NO. S 1078

REV: A

TITLE: GPT-40K FORCED AIR COOLING MODIFICATION - KIT-262

FIGURE 1

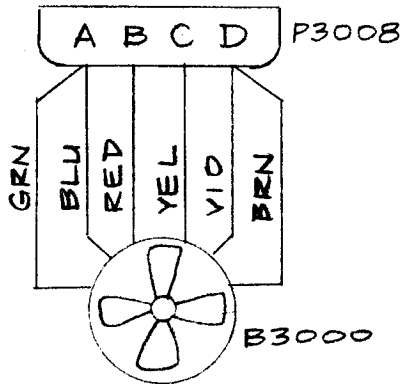
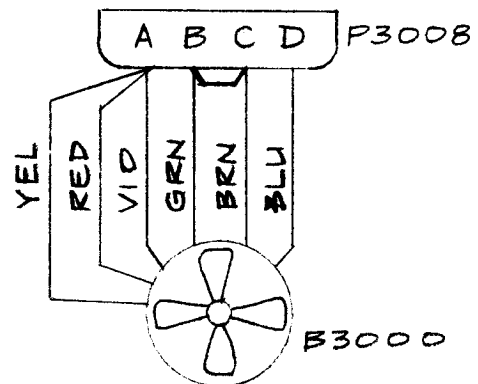
7. Disconnect top front fan plug, Symbol P3008 and re-wire per Figure 1. Be sure to add jumper wire, Item 4 between Pins B and C.
8. Cut off and remove the two "U" channel supports which previously mounted the transformer removed in Step 2. Remove shaded area as shown in Figure 2.

RE-WIRING OF FRONT TOP FAN

OLD WIRING
FOR 230V

NEW WIRING
FOR 115V

FIGURE 3

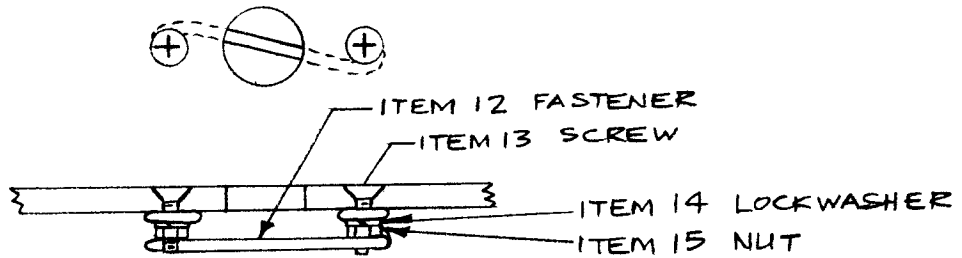
14. Mount 8 ea fasteners, Item 12 (FS102-1) to new base shield in holes surrounding large rectangular cutout per Figure 3, using hardware, Items 13, 14, and 15.

24. Take the new right side shield, Item 19 (LD2061/MS4654) and assemble six fasteners, Item 12 (FS102-1) to shield in holes provided (per Figure 3) with hardware, Items 13, 14, and 15.

28. Assemble sixteen fasteners, Item 12 (FS102-1) to new right side panel, Item 22 (MS4880) in holes provided (per Figure 3) with hardware, Items 13, 14, and 15.

FIGURE 4

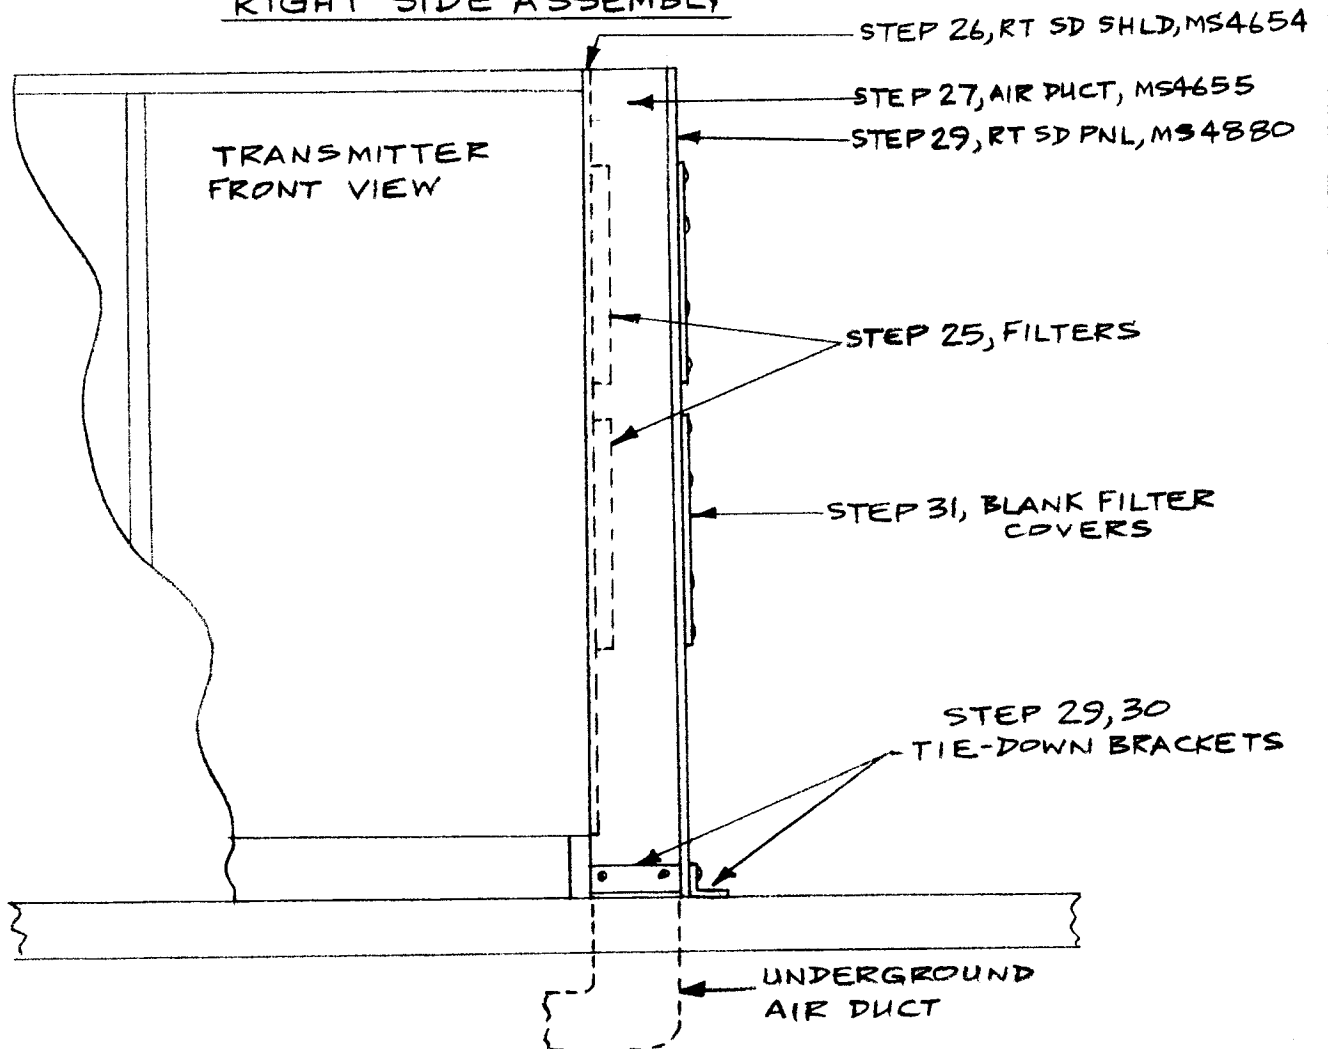
25. Remove two air filters from the old right side panel, MS2116, and install them into the two large perforated areas in the new side shield. Retain filters on shield by means of the two retaining brackets, Item 20 (MS4654-1) which mount into fasteners. Refer to Figure 4.

26. Assemble resultant right side shield assembly to frame using hardware for old shield. Refer to Figure 4.
27. Assemble right side air duct, Item 21 (MS4655) with hardware previously supplied to mount right side panel. Refer to Figure 4.

29. Assemble new right side panel, Item 22 (MS4880) to right side duct with hardware, Items 23 and 24. Also assemble tie-down bracket, Item 25 (MS4657) in bottom row of holes. Refer to Figure 4.

30. Assemble new front and rear tie-down brackets, Items 26 and 27 (MS4882-1 and MS4882-2) to front and rear of right side duct with Items 23 and 24. Refer to Figure 4.

31. Assemble two blank filter panels, Item 18 (MS2256) to right side panel. Refer to Figure 4.
32. Slide out the CPP-2 Power Supply in the first (Aux) frame, (2nd unit from bottom), and remove the top cover. Remove the air filter from the front panel and replace with blank plate, Item 29 (MS5000) with lips facing into unit. Replace top cover, slide unit back in rack, and fasten.
